Technical Service Bulletin

SUBJECT:		No: TSB-16-51-001	
WIND NOISE FROM DOOR MIRROR		DATE: October, 2016	
		MODEL: 2015-16 Lancer models	
CIRCULATE TO:	<input type="checkbox"/> GENERAL MANAGER	<input checked="" type="checkbox"/> PARTS MANAGER	<input checked="" type="checkbox"/> TECHNICIAN
<input checked="" type="checkbox"/> SERVICE ADVISOR	<input checked="" type="checkbox"/> SERVICE MANAGER	<input checked="" type="checkbox"/> WARRANTY PROCESSOR	<input type="checkbox"/> SALES MANAGER

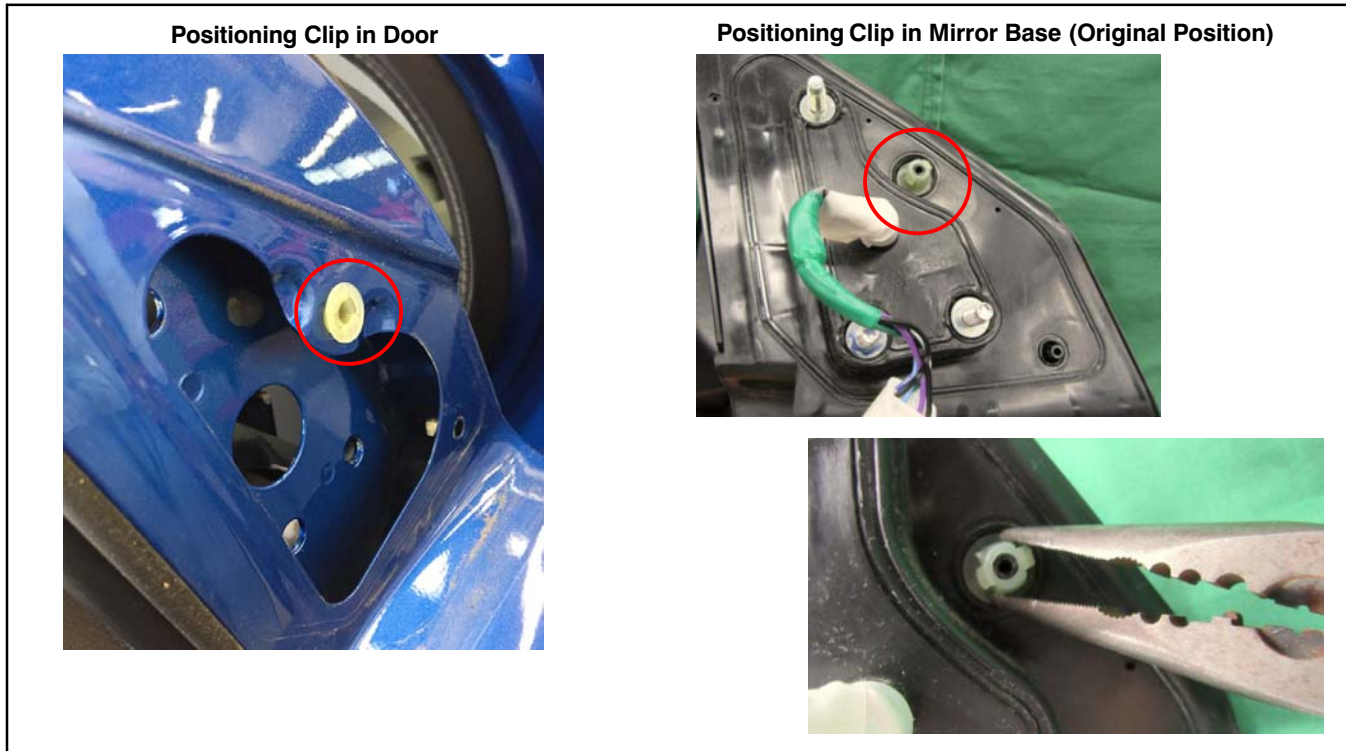
2. Once the door mirror is removed, locate the positioning clip.

NOTE: The positioning clip is often located in the door sheet metal after installation. The original position is in the mirror base as shown below.

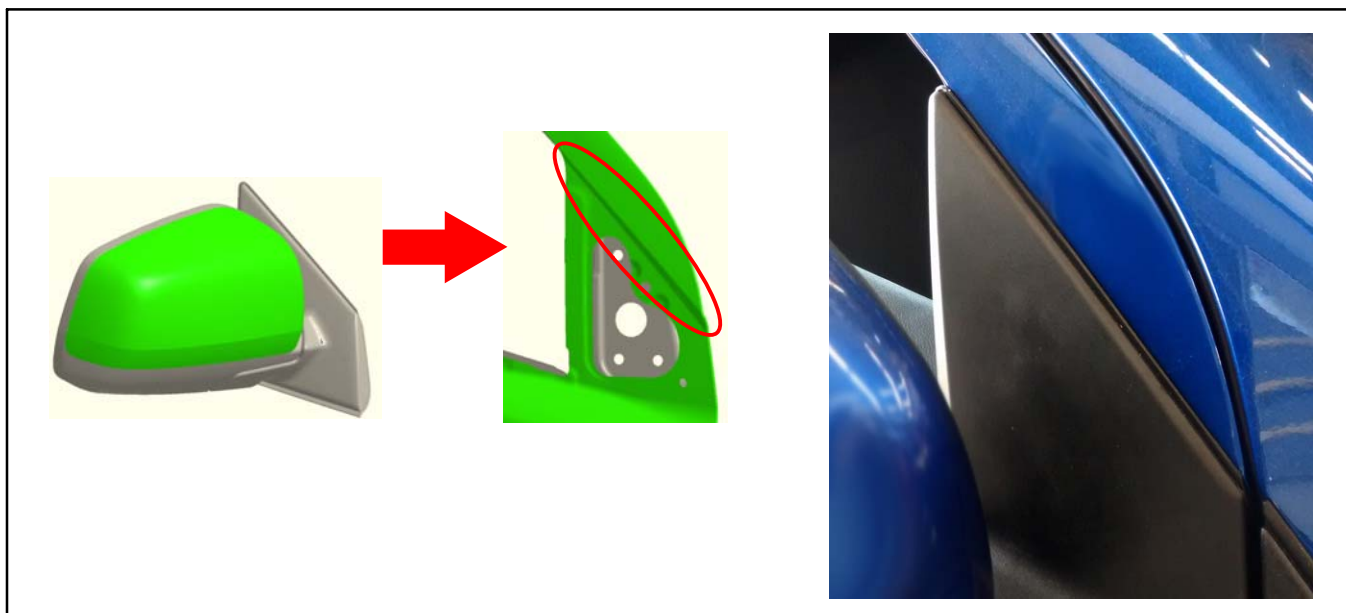
3. Remove the positioning clip and discard.

4. Reinstall the door mirror assembly onto the door panel.
Be sure to align the door mirror base along the door panel line (red oval area) as shown below.
Do NOT allow the mirror assembly to overlap the edge when installed.
